Response on Judd Street - One Way Traffic and Public Realm Improvements From Camden Cycling Campaign

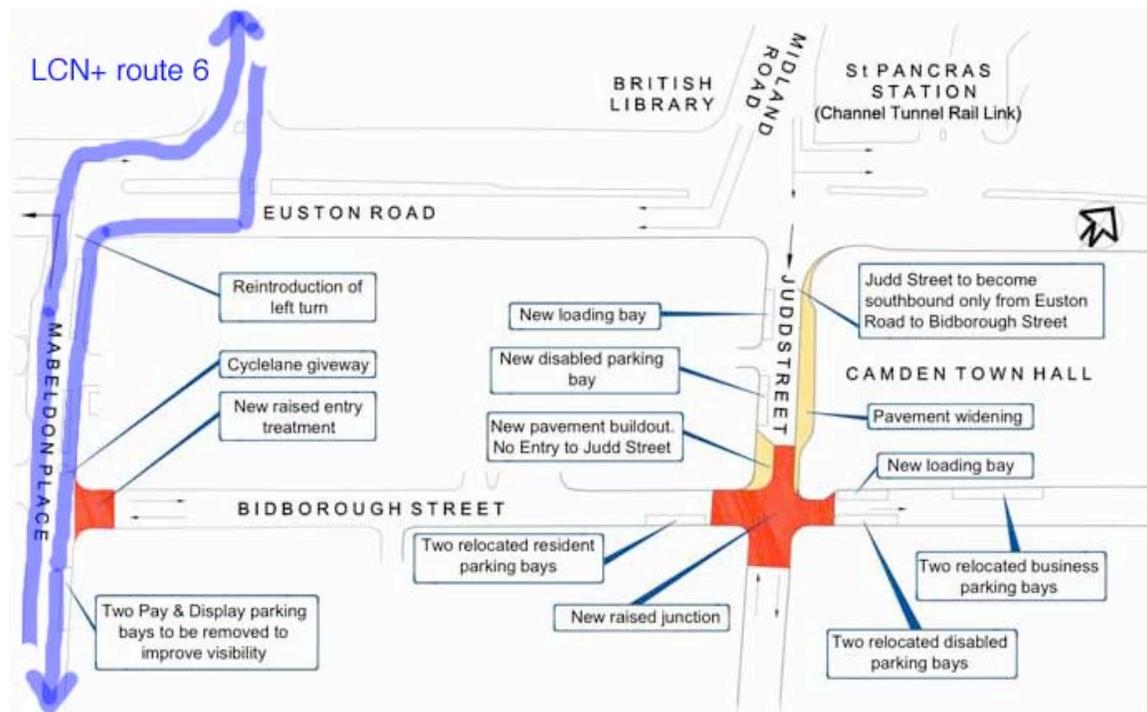
CCC objects to the displacement of vehicle traffic into Bidborough Street and Mabledon Place and the left turn from Mabledon Place into Euston Road for the following reasons:

- the cycle route in Mabledon Place is very heavily used;
- the increase of vehicle traffic in Bidborough Street will be a hazard for southbound cyclists at its junction with Mabledon Place;
- the new left turn at Mabledon Place is clearly detrimental to both cyclists' and pedestrians' safety.

These issues are all illustrated in the above figure, which is taken from the consultation document. The line followed by LCN+ route 6 has been added.

Currently there is virtually no vehicle traffic in Bidborough Street. We understand that the existing priorities will continue at this junction, that is, Bidborough Street will be the 'give way' street. However, the consultation document shows a 'give way' for southbound cyclists at this junction. This proposal does not make sense: you cannot have both parties giving way at the same junction.

It is well known that vehicle drivers are poor at giving way to cycle tracks at junctions. In this particular case, they may think that Mabledon Place is one-way and fail to check on the right for cyclists. There is a potential for collisions here, which even the best designs may have difficulty in preventing.

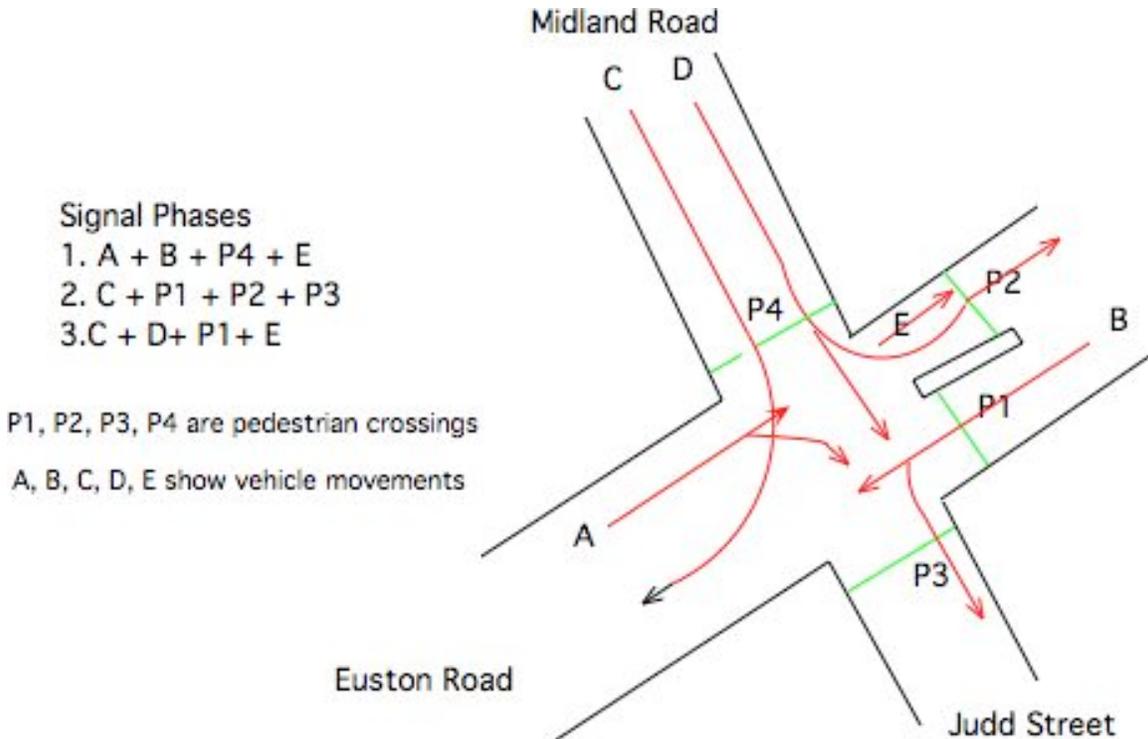
The consultation document does not provide the details of the proposed design for the junction of Euston Road/Midland Road/Judd Street. However, David Braine of TfL has very kindly provided us with a copy of Buchanans' report for TfL on 'Kings Cross Area Modelling'. From this we have learned that there will be inadequate provision for pedestrians at this junction and absolutely no provisions for cyclists. The report recommends that pedestrians should be provided with a staggered crossing over Euston Road to the east of the junction as illustrated in the figure below.

As both halves of the pedestrian crossing are on the same signal phase, most pedestrians will have to wait two full light cycles to cross, plus another one to get across Judd Street.

CCC proposes that at this junction an all pedestrian (and cycle) phase with pedestrian crossings on all arms as well as a right turn for cyclists out of Judd Street should be provided. This should make it possible for cyclists to be provided with a Toucan crossing over Euston Road to allow them to cross from Judd Street and into a northbound contraflow cycle lane on Midland Road.
